Wizards Workshop

July 25, 1980
Issue 10-15

TABLE OF CONTENTS

1430, 1440, 1441, 1460, 1461 -- MISSING FIBER WASHER ON POWER SUPPLY BOARD

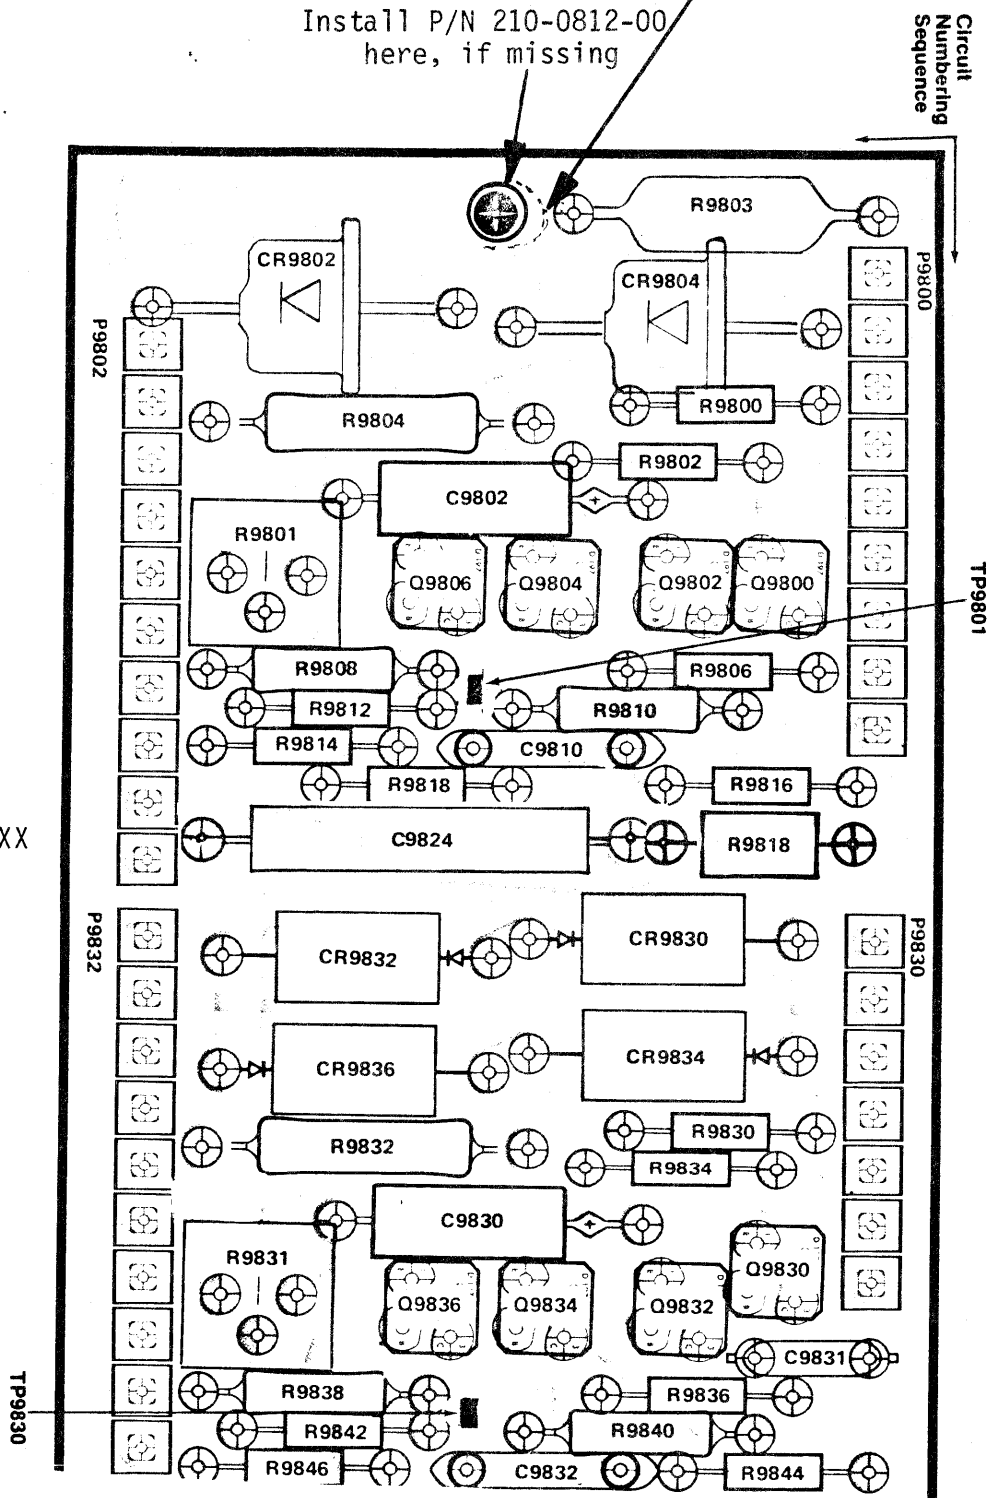
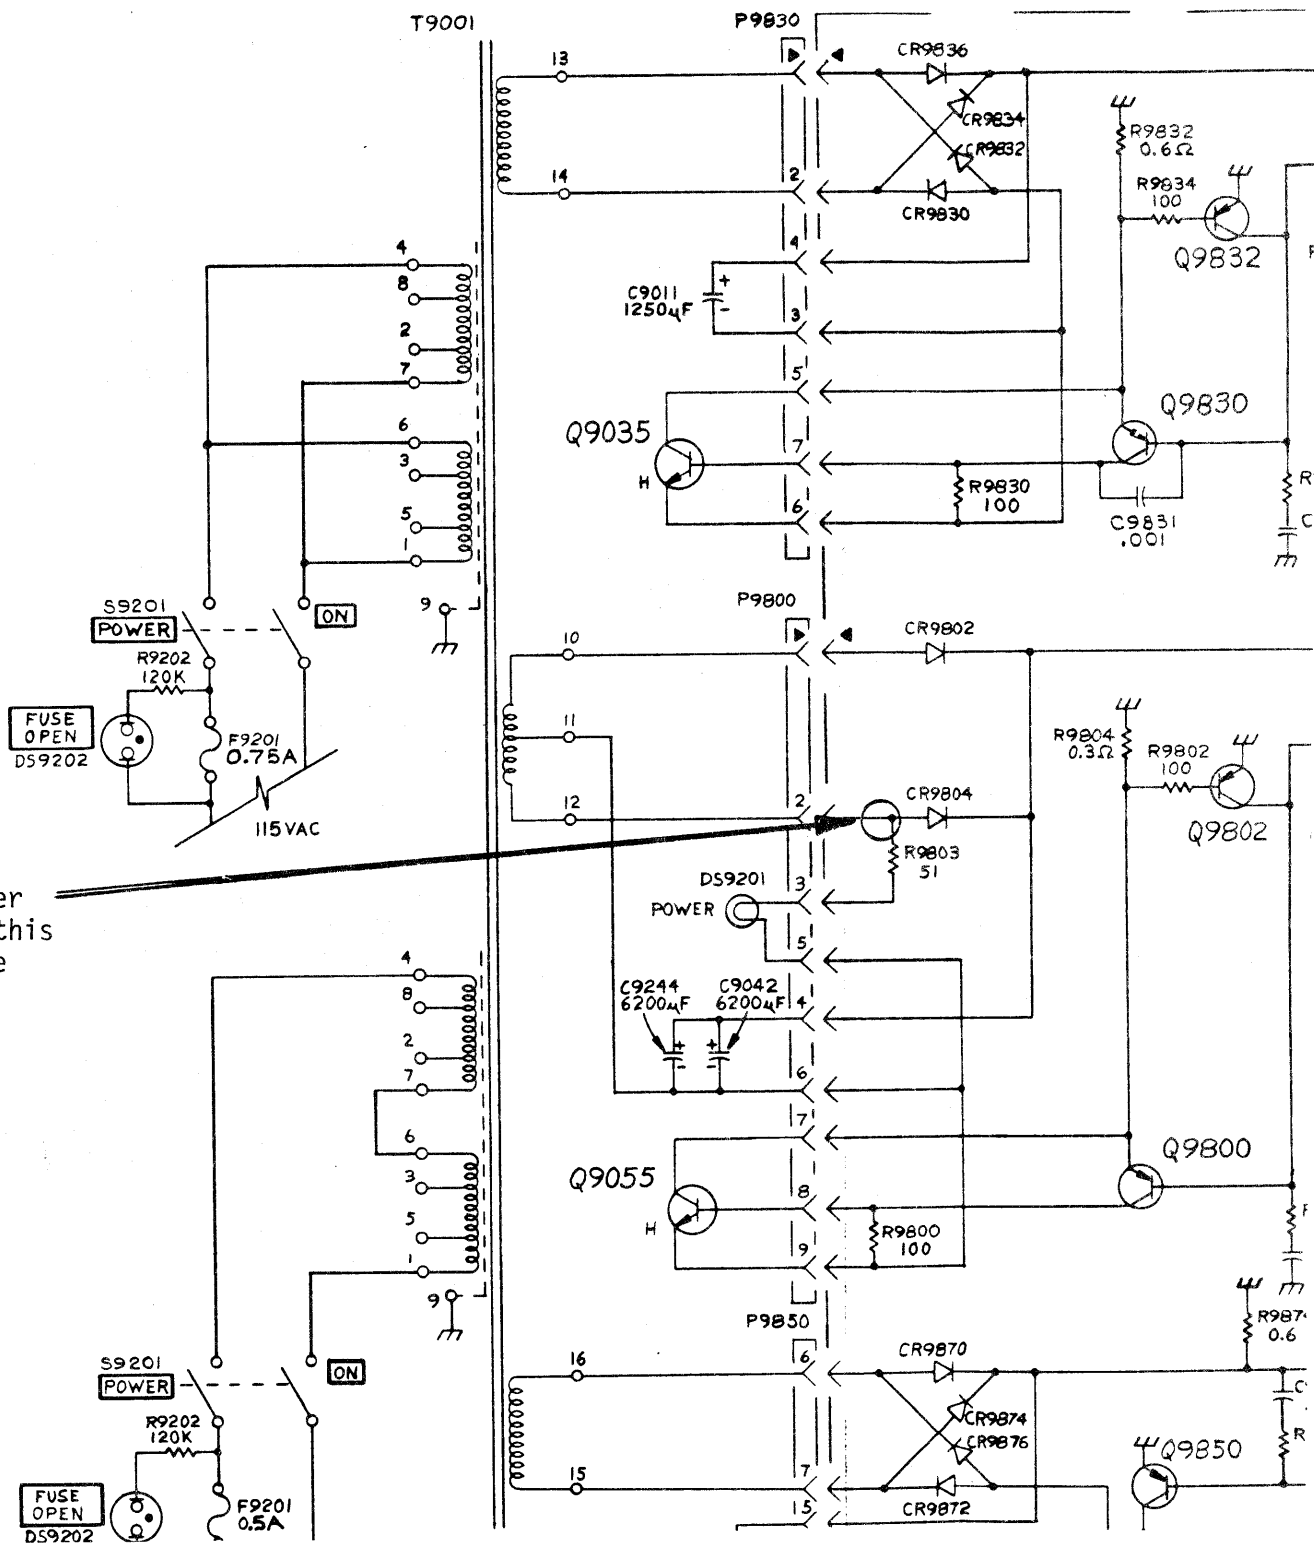
The Manufacturing line had been installing a fiber washer (P/N 210-0812-00) under the metal washer on the board mounting screw that is near R9803 (see following board layout of power supply board, 670-1473-XX). This washer was to prevent R9803 from being shorted to ground due to close spacing of the circuit board pads. An unknown number of instruments have been shipped without this washer. It is possible that any slippage of the circuit board could cause R9803 to contact the mounting screw. When R9803 is grounded, the +5 volt supply will increase to approximately 9 volts. The power supply is normally not damaged, but other components in the instrument may be.

Please check all 1430, 1440, 1441, 1460, and 1461 instruments that come in for service and insure that the fiber washer is installed and that the power supply mounting screws have remained tight.

If board slips,
short could occur here.

Install P/N 210-0812-00
here, if missing //

ENHANCEMENT TO THE SECTOR CARD TEST FIXTURE (067-0745-00)

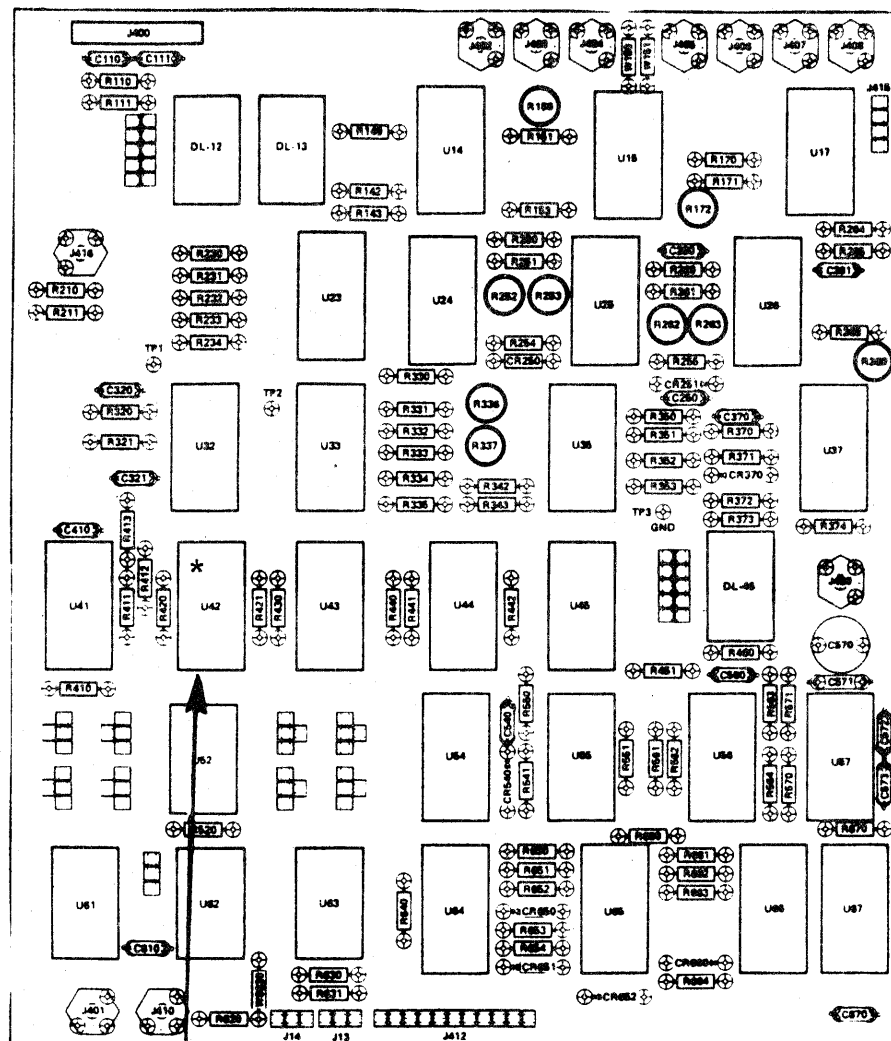
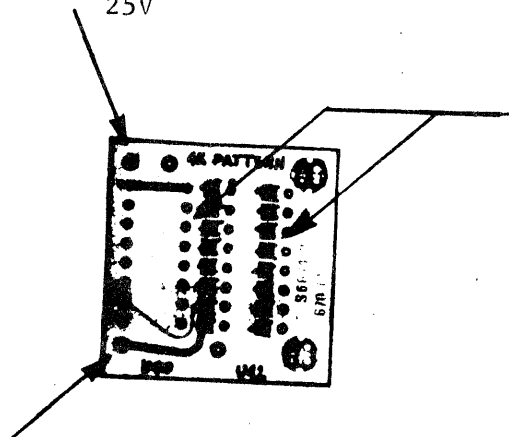
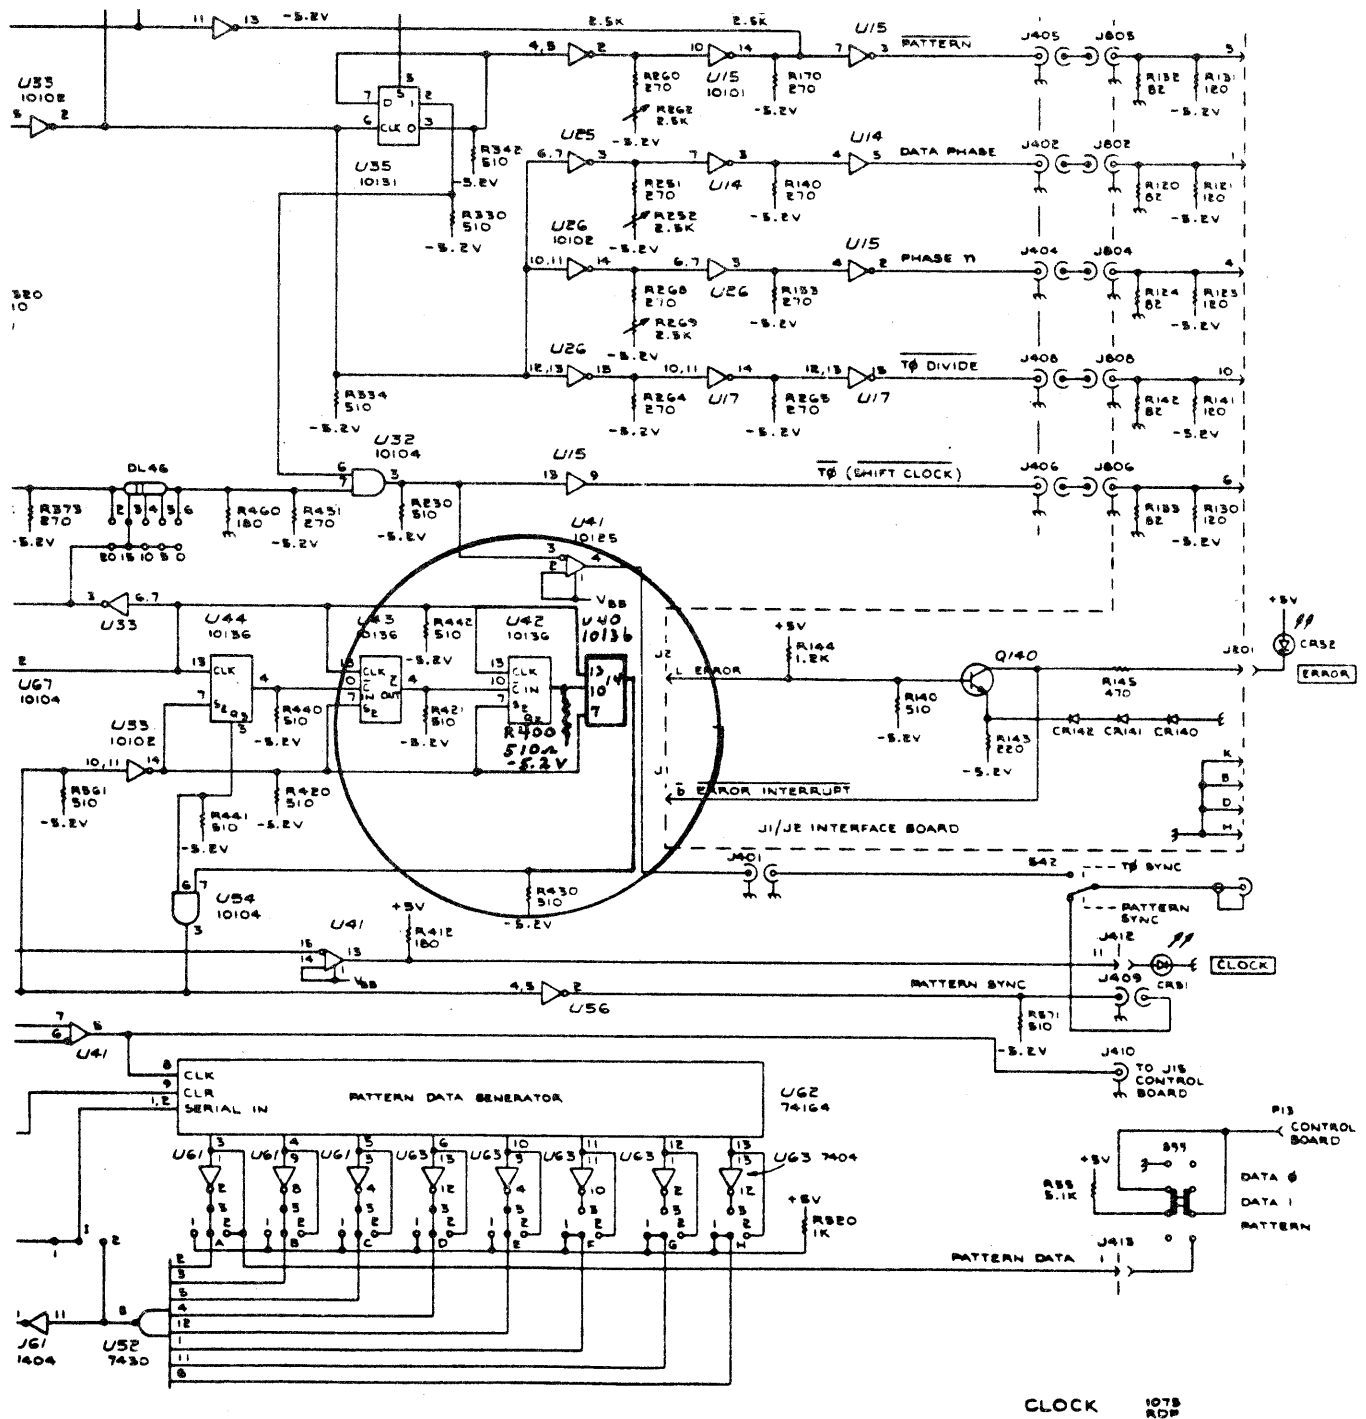
This modification enables testing of D70 and D80 Sector Cards. It allows the LOOP and LOAD functions of the Sector Card Test Fixture to generate 4104 bits of data instead of 1032 bits.

On the clock card, remove U42, the MC10136 (156-0641-00). Add the new 4K Pattern Circuit, Assembly 670-6196-00, to the clock circuit, Assembly 670-4191-02. The clock card part number changes from 670-4191-02 to 670-4191-03 when this piggy-back pattern circuit board is added.

Insert 4K Pattern Circuit
670-6196-00 into socket located at U42.

There is no 040- Kit established for this mod. The 4K Pattern board (670-6196-00) may be ordered through CMS.
